**EXPLANATION OF SIGNIFICANT DIFFERENCES
MIDDLE WATERWAY
COMMENCEMENT BAY NEARSHORE/TIDEFLATS SUPERFUND SITE
FEBRUARY 2002**

EXPLANATION OF SIGNIFICANT DIFFERENCES COMMENCEMENT BAY NEARSHORE/TIDEFLATS SUPERFUND SITE

The purpose of this Responsiveness Summary is to present and respond to public comments submitted to EPA on the draft Middle Waterway Explanation of Significant Differences (ESD) to the Record of Decision (ROD) for the cleanup of the Commencement Bay Nearshore/Tideflats Superfund site. This Responsiveness Summary has been prepared in accordance with Section 117 of the Comprehensive Environmental Response, Compensation, and Liability Act (CERCLA) and July 1999 guidance document entitled *A Guide to Preparing Superfund Proposed Plans, Records of Decision, and Other Remedy Selection Decision Documents* (EPA 540-R-98-031). The public comment period was held from August 24 to September 24, 2001, and then extended to October 9, 2001. During the public comment period, 80 comment letters were received from citizens along with comments from the Puyallup Tribe, city and state representatives as well as from federal resource agencies.

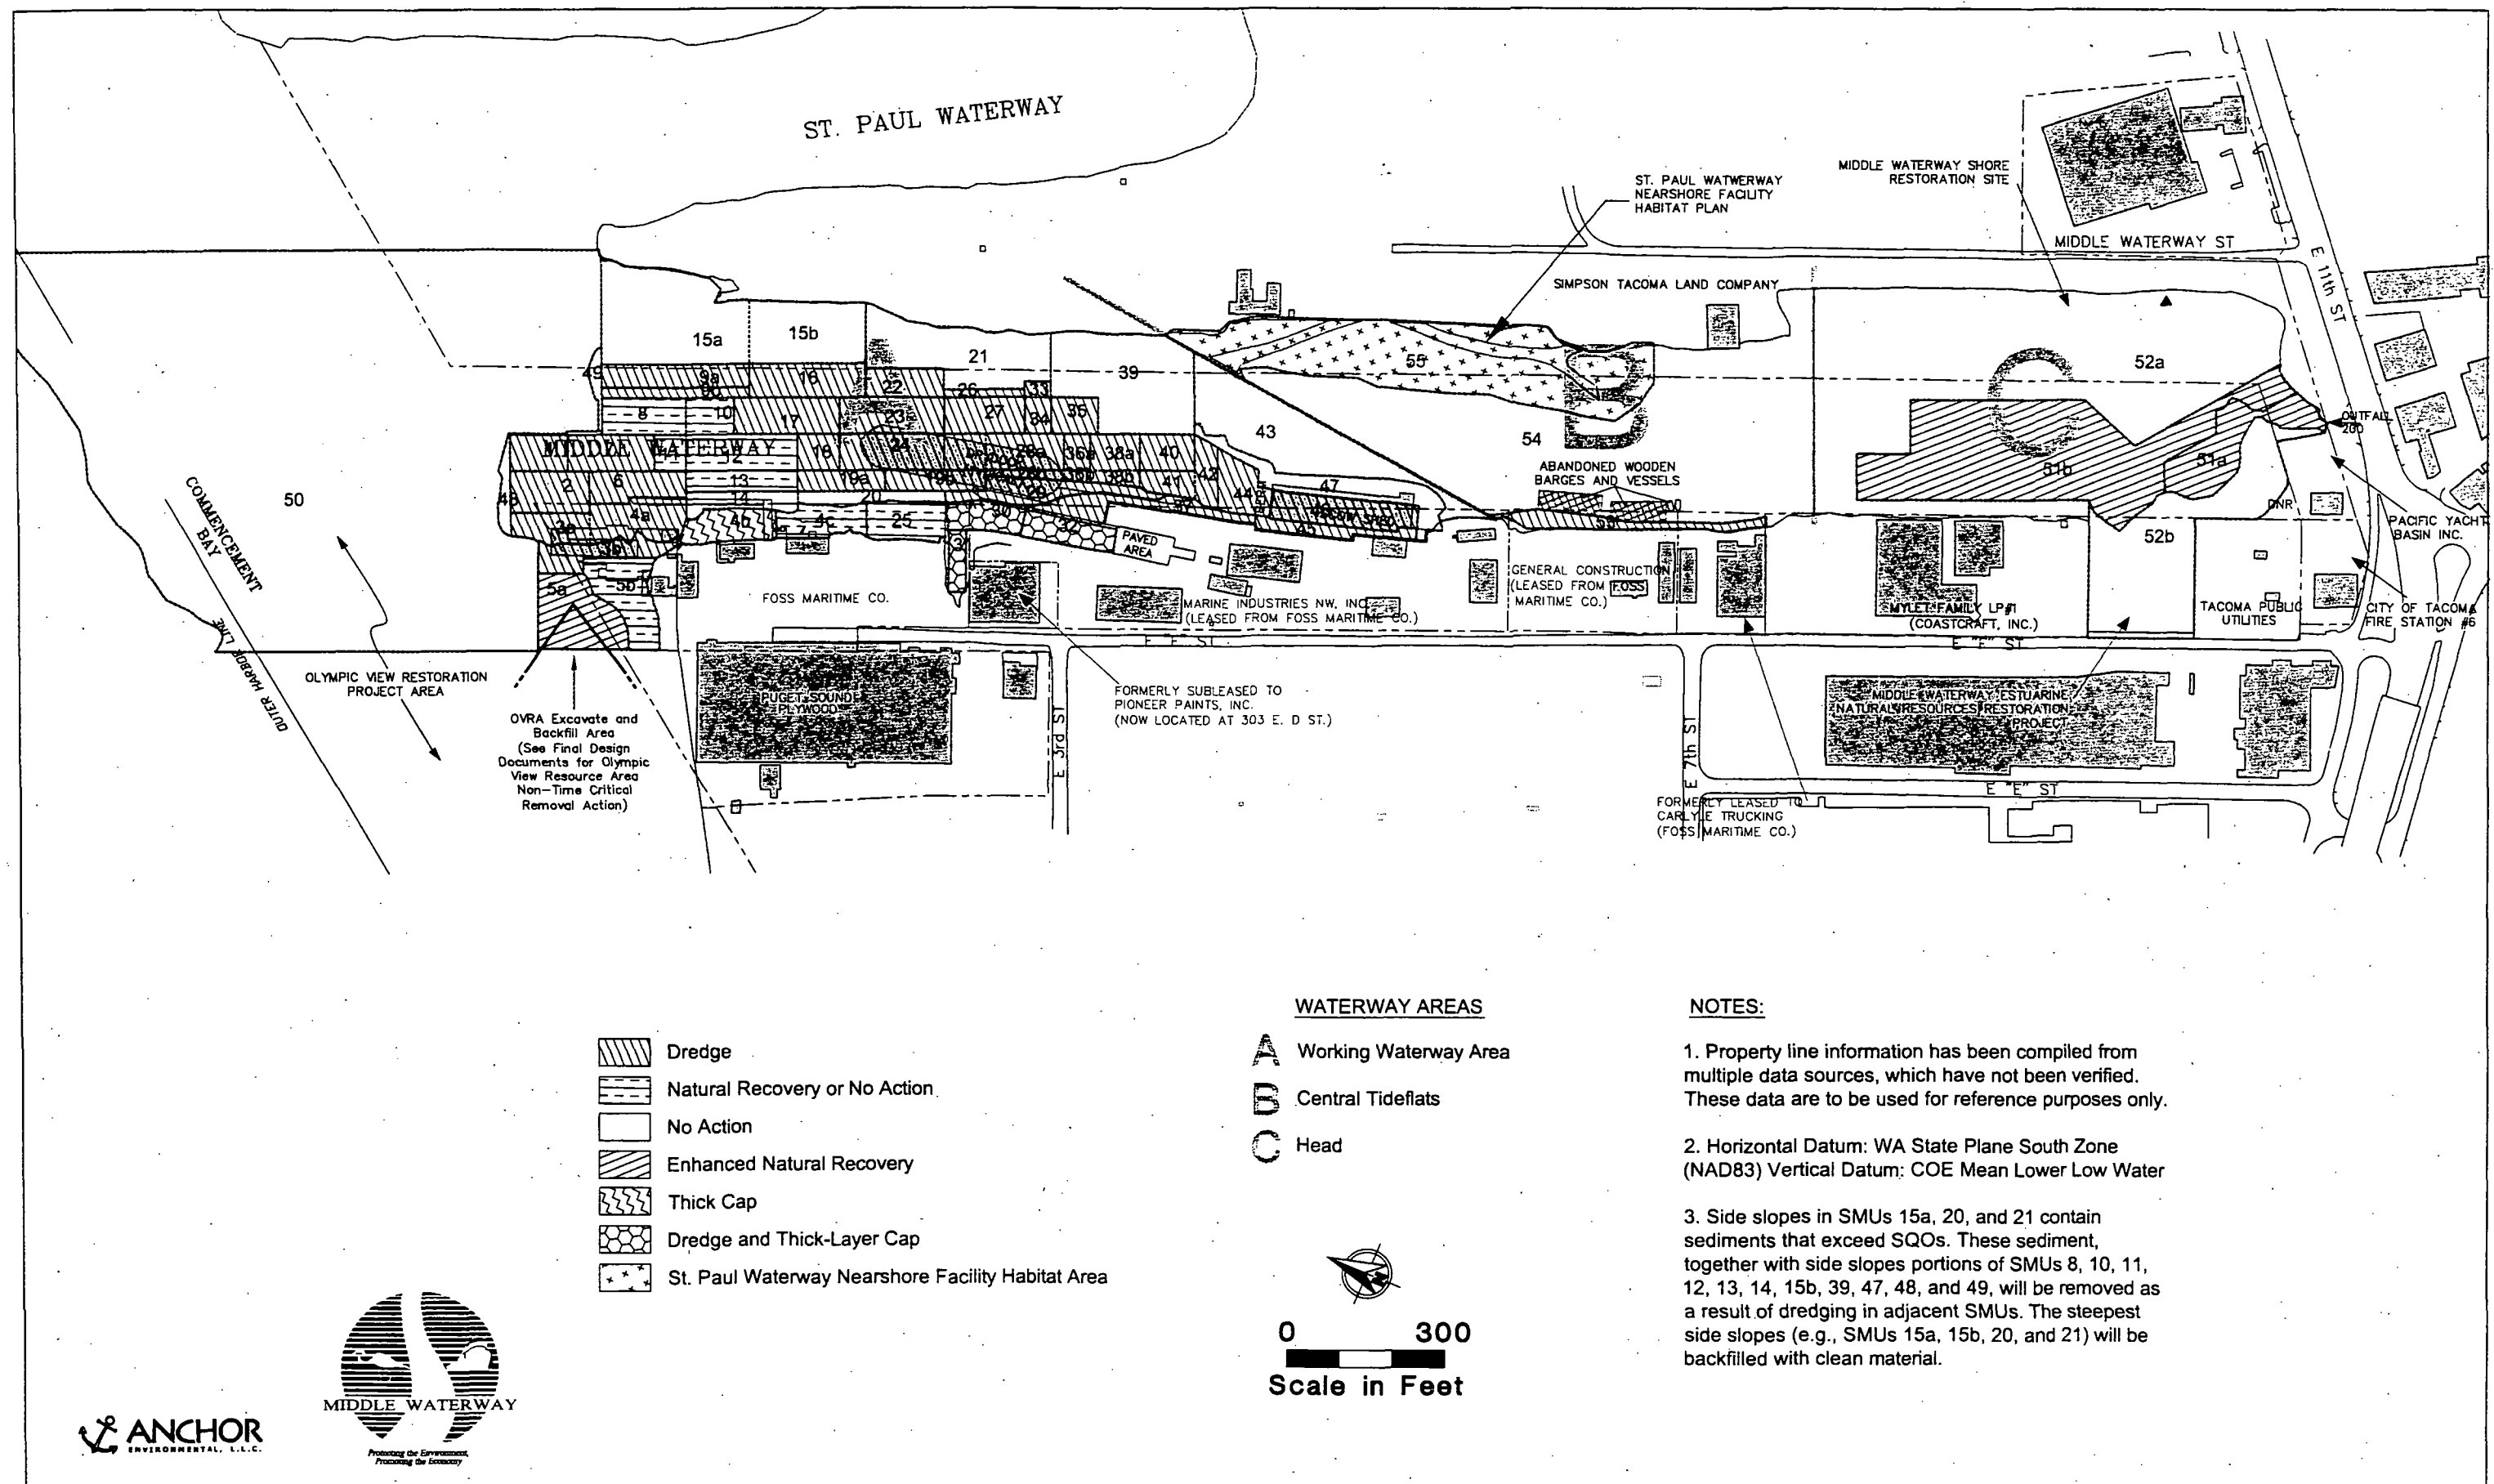
4. Comment: Figure 2 and Appendix B. The draft ESD and Final Evaluation of Remedial Options Report (November 2000) do not provide cross-sections of detailed information on the dredge prism and the effect of no action/natural recovery on navigation in SMUs 8 and 10-14, which is the active public navigational portion of the waterway.

41. Comment: Section V. A. Area A, pg. 7. In the text, problem sediments in SMU 15a will be dredged, but Figure 2, shows this area as no action. Please correct Figure 2. (*NOAA*)

68. Comment: In addition, please correct Figure 2 and remove the reference to Simpson Tacoma Kraft Company, as we have previously requested. Simpson Tacoma Land Company is a separate corporation and is the owner of this property. *(Simpson)*

72. Comment: The ESD should also note on page 6 that there is essentially no cleanup required on the Middle Waterway tidelands owned by Simpson Tacoma Land Company (see dotted property line on Figure 2 of draft ESD). (*Simpson*)

Response to Comments 4 and 5: Existing data for SMUs 50 and 15a of the waterway are somewhat limited. These data, including data collected as part of the Middle Waterway pre-remedial design investigations, show very little justification for active sediment remediation in this area. Limited surface sediment exceedances of chemical SQOs at MW022 are overridden by positive biological test results. The side slope of SMU 15a, potentially contaminated based on the closest sampling results from MW027, will be removed in connection with dredging planned in adjacent SMU 9a. In general the data suggest that any navigation dredging needed in the future in this area is not likely to be impacted by contaminated subsurface sediments. In the unlikely event that future dredging uncovers conditions posing a threat to human health or the environment, EPA will reconsider the need for active remediation.

Response to Comments 41 through 43: While these SMUs are not designated for comprehensive dredging, the sideslopes of these SMUs, the areas most closely associated with the SQO exceedances, will be removed in connection with dredging in adjacent SMUs. This is documented in footnote 3 to Figure 2 in the ESD.
